# ***Louisville Revitalization Commission***

**SUBJECT:** Discussion/Direction: Front & Center Project – 30% Design

**DATE:** MARCH 11, 2026

Staff received some initial feedback from LRC and City Council at the February 25, 2026, joint meeting; however, several questions from LRC remained. Responses to those questions are included as an attachment to this memo.

# OVERALL CATENARY ARRANGEMENT

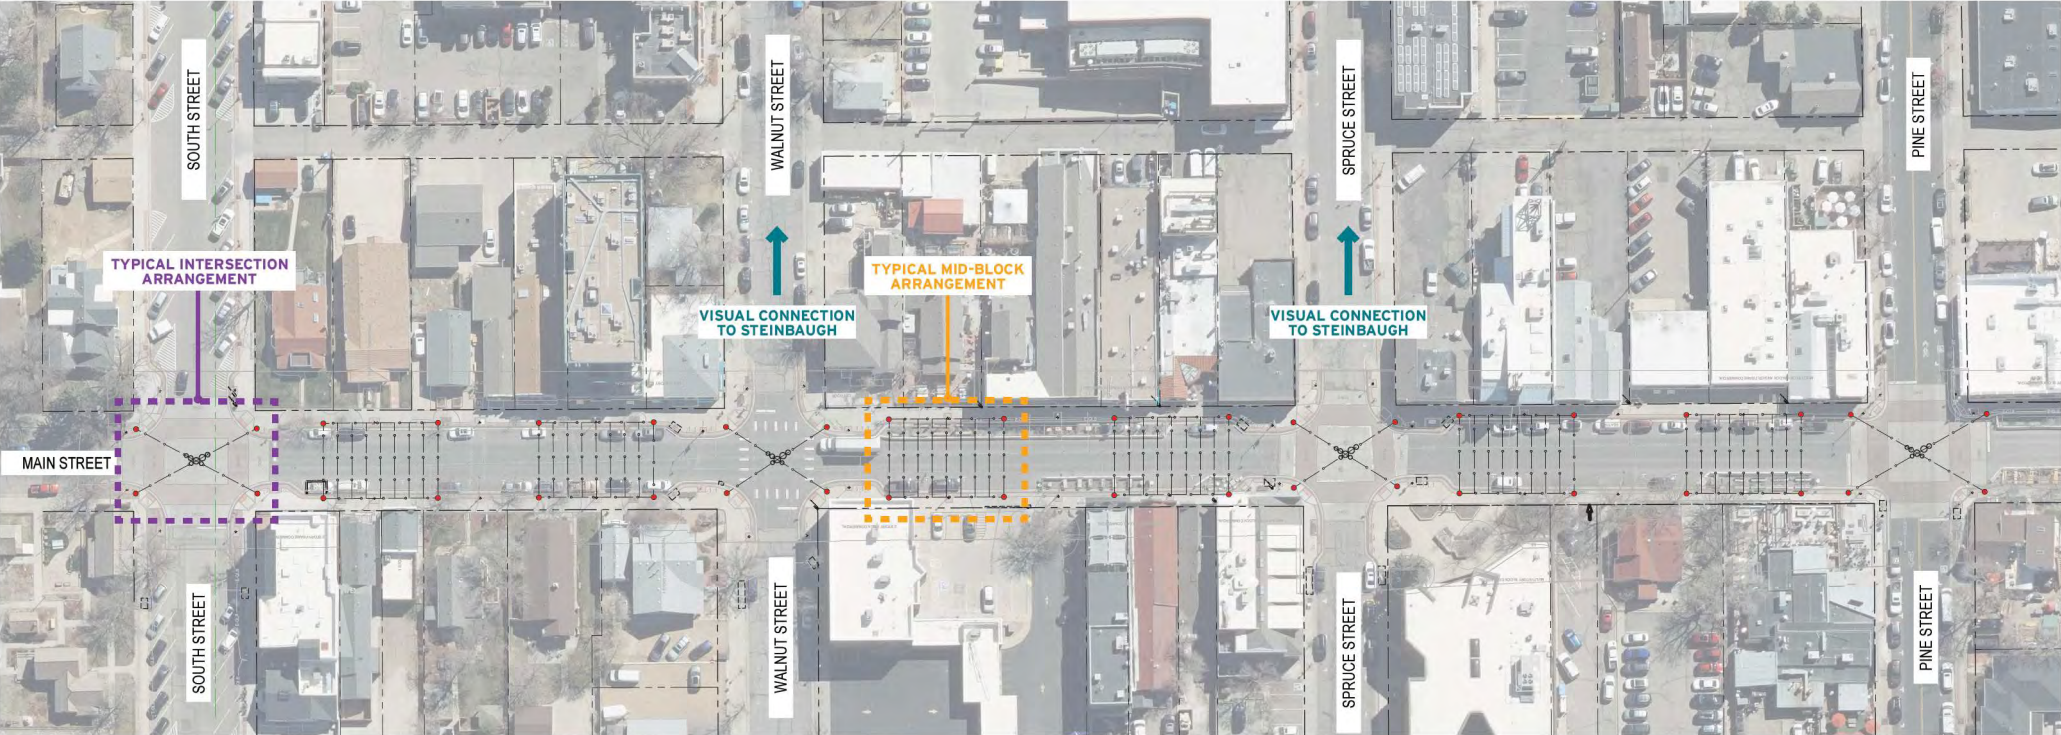
**Question 2:** Lighting on Main – What exactly is included in those numbers? Kurt mentioned several different lighting ideas, but I'm not sure which ones are represented in the budget or whether they vary in cost.

**Response:** The concept plan showing the improvements associated with these costs is included as an attachment (“Overall Catenary Arrangement”). This includes new poles, foundations and string lighting at four (4) Main St intersections including: South Street, Walnut Street, Spruce Street, and Pine Street. It also includes string lighting at mid-block locations along the 3 blocks located between Pine and South Street.
